**REVISED FINAL
REMEDIAL DESIGN REPORT
FOR THE ASH LANDFILL OPERABLE UNIT
SENECA ARMY DEPOT ACTIVITY**

SUBJECT: Revised Final Remedial Design Report for the Ash Landfill Operable Unit at Seneca Army Depot Activity; Contract FA8903-04-D-8675, Delivery Order 0012, CDRL A001G and A013

Response to Comments from the United States Environmental Protection Agency

PARSONS	
SENECA ARMY DEPOT ASH LANDFILL REMEDIAL DESIGN	
ENVIRONMENTAL ENGINEERING	DWG NO 744538-01400
FIGURE 7-3 LONG-TERM GROUNDWATER MONITORING DECISION DIAGRAM	
SHEET 1 OF 2	JUNE 2006

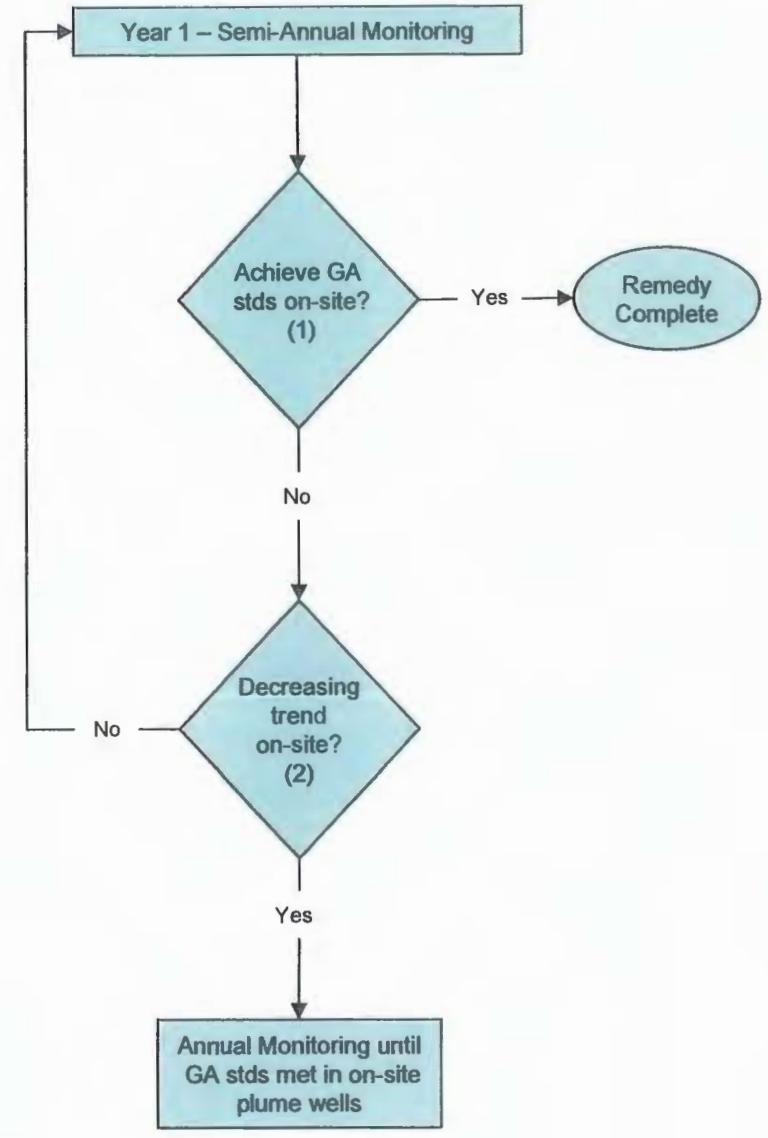
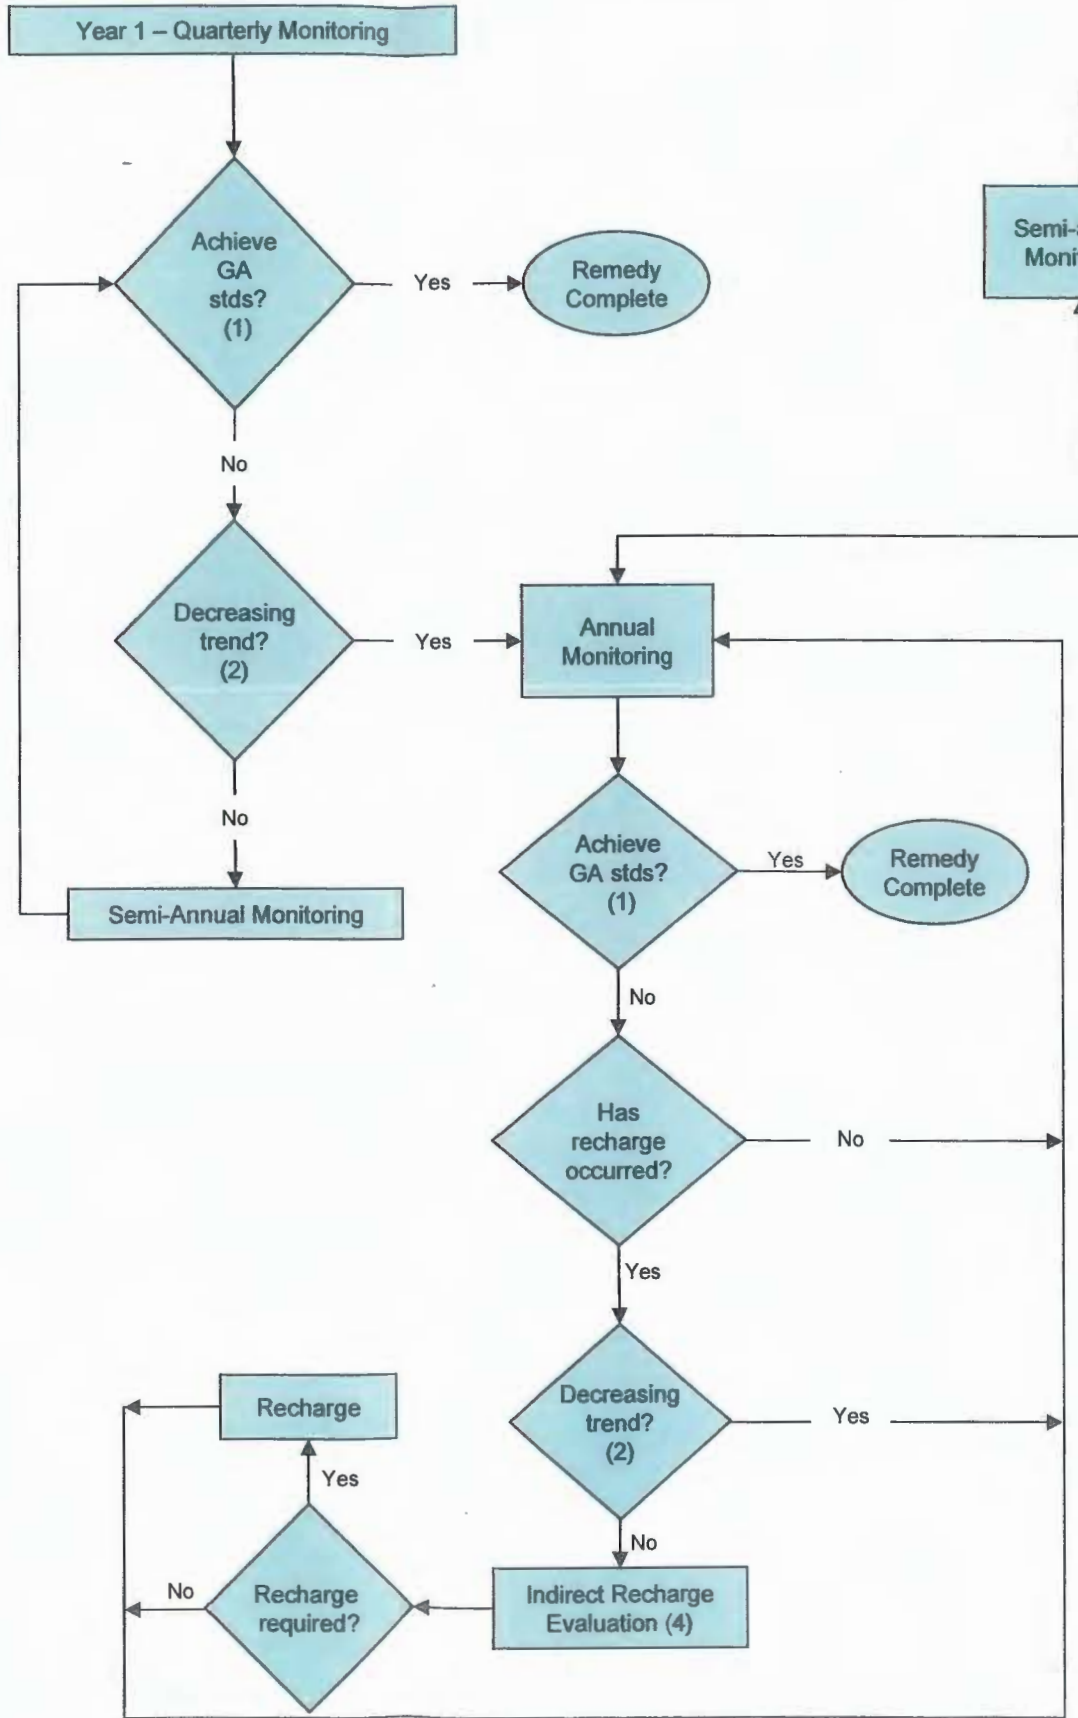
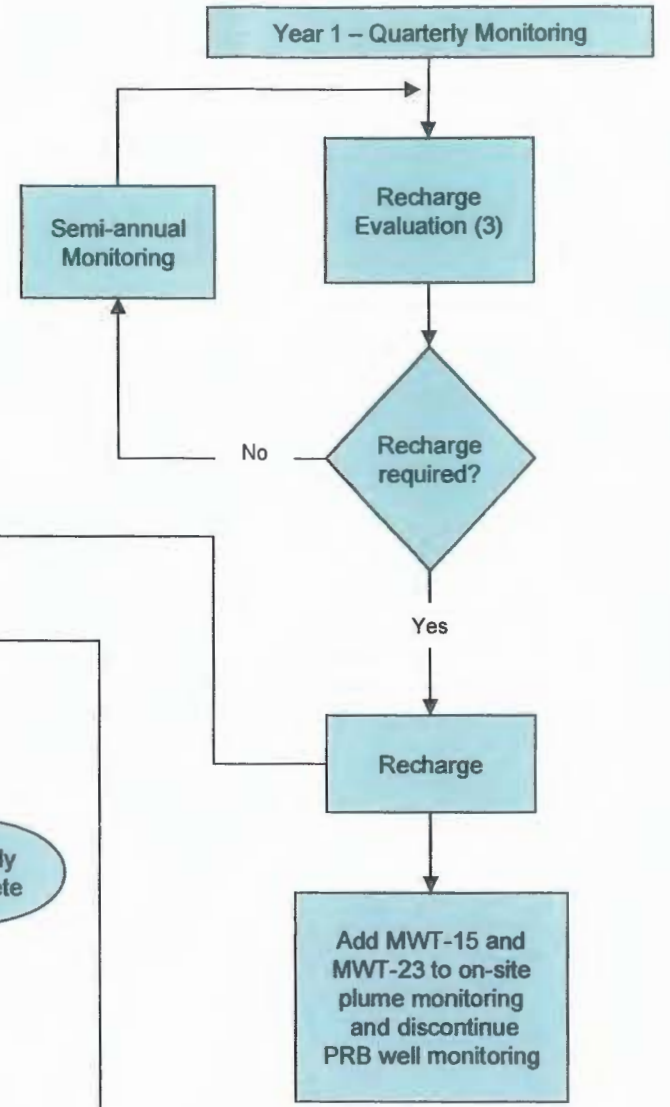
Figure 7-3, Notes, Item 1- Achieving GA Stds on site:

Comment 9: Section 7.2.4, Monitoring Frequency, page 7-4. This section and Figure 7-3 indicates that at a minimum annual sampling will be conducted until two successive rounds of sampling the on-site plume wells show that the GA standards have been achieved. The ROD, Section 1.0, Description of the Selected Remedy, states that additional review of the remedy is necessary if a wall material other than iron is selected. A review of the remedy's effectiveness shall be completed one year after the walls are installed and subsequent annual reviews performed until the first five year review. The Report provides a sampling schedule that extends out for 10 years, but a minimum number of years for monitoring is not dictated in the Report. Please revise the Report to indicate that a minimum of five years worth of monitoring will occur in order to meet the requirements of the ROD.

Response 1: The purpose of the long-term monitoring plan and, specifically, of the decision diagram outlined in Figure 7-3, is to establish a defined process for evaluating the groundwater monitoring program and for detailing the frequency and duration of monitoring. It is the Army’s desire that the long-term monitoring plan be definitive as to when monitoring requirements would terminate. The ROD states that monitoring will be conducted at the site until NYSDEC GA standards are achieved. The Army’s original wording provides a clear blueprint for when the GA standards in the on-site wells have been achieved. Currently, the Army has recommended that after two successive monitoring events, if GA standards are achieved in all on-site plume wells, the remedy would be complete and no further monitoring would be required for the Ash Landfill Operable Unit. Under the Army’s proposed plan, since monitoring would cease after two successive rounds of acceptable data as currently defined, there would not be a “subsequent” round. Therefore, the text in the note on Figure 7-3 remains unchanged.

Response 2: Graphs and statistics will be used, as appropriate, to determine the trend of the analytical data. The text in Figure 7-3 and on Page 7-5 has been modified.

Response 9: Since mulch has been used in the remedy rather than iron, an annual review will be done for the first 5 years. Text has been revised to state that monitoring will be done for a minimum of 5 years to fulfill 5-year review requirements. Additionally, the purpose of Table 7-3 is to provide an example of the sampling frequency over the first ten years of monitoring based on the flow diagram presented in Figure 7-3 and a stated set of assumptions. In Table 7-3, ten years of monitoring was selected for convenience and does not suggest that monitoring will be limited to ten years. The duration of monitoring will be determined by site data according to the flow diagram.
